Subject: Completion of Midterm Review, Task ID # 5078, Canyon Fuel Company, LLC, Banning
Siding Loadout, C/007/0034

Title: Completion of Midterm Review Response, Banning Loadout, C/007/034, Task ID #5078

Response to Banning Loadout Midterm Deficiencies

Subject: Completion of Midterm Review, Task ID # 5078, Canyon Fuel Company, LLC, Banning Siding Loadout, C/007/0034

Banning M&RP, Exhibit 5-7A Added
Banning Loadout, Permit Number C/007/034

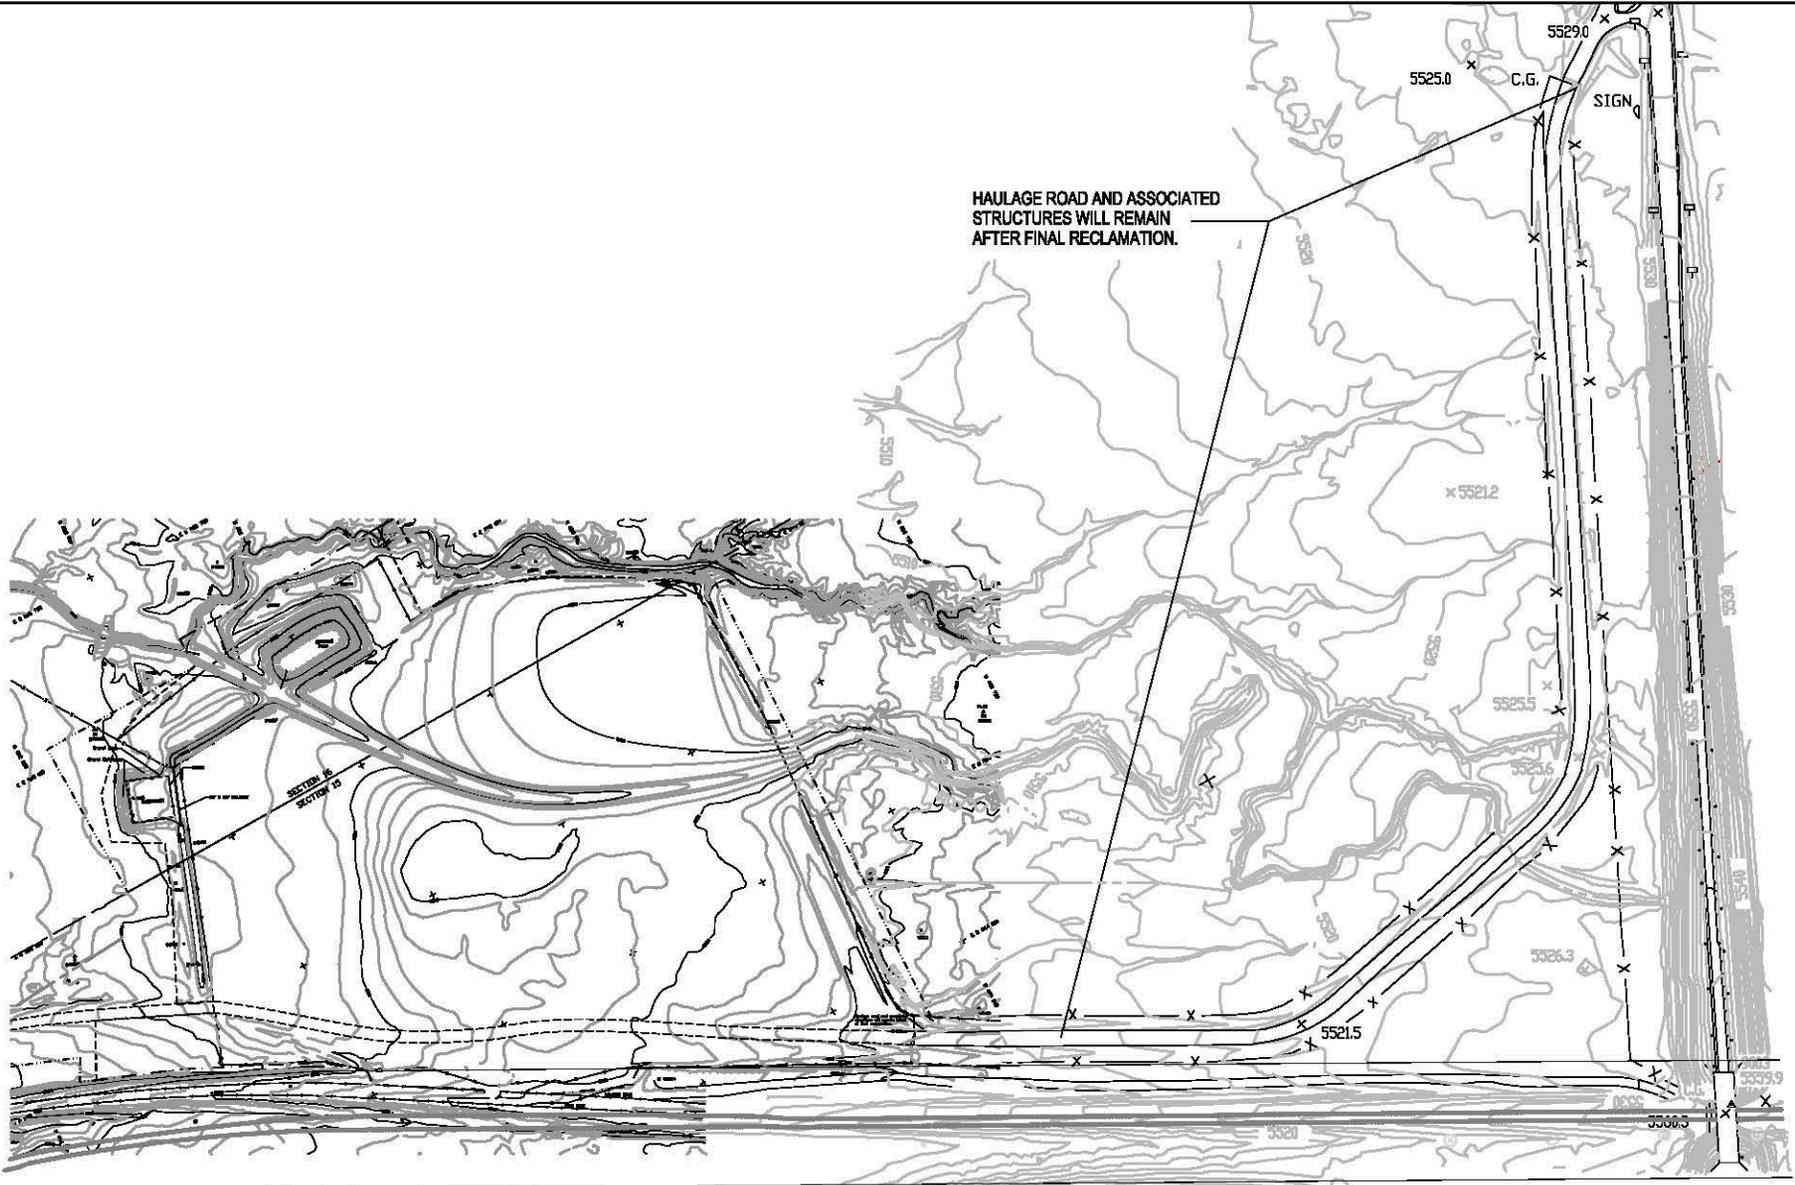
R645-301-534: *The Permittee will amend the narrative of Chapter 5 Section R645-301 -534.100 to clarify what portions of the operational roadways will remain post reclamation of the site.*

Response: Chapter 5, Section R645-301-526.100, pg 5-27 the text is revised to clarify what portions for the haul road remain after reclamation. Exhibit 5-7A was also added to help clarify the haul road after reclamation.
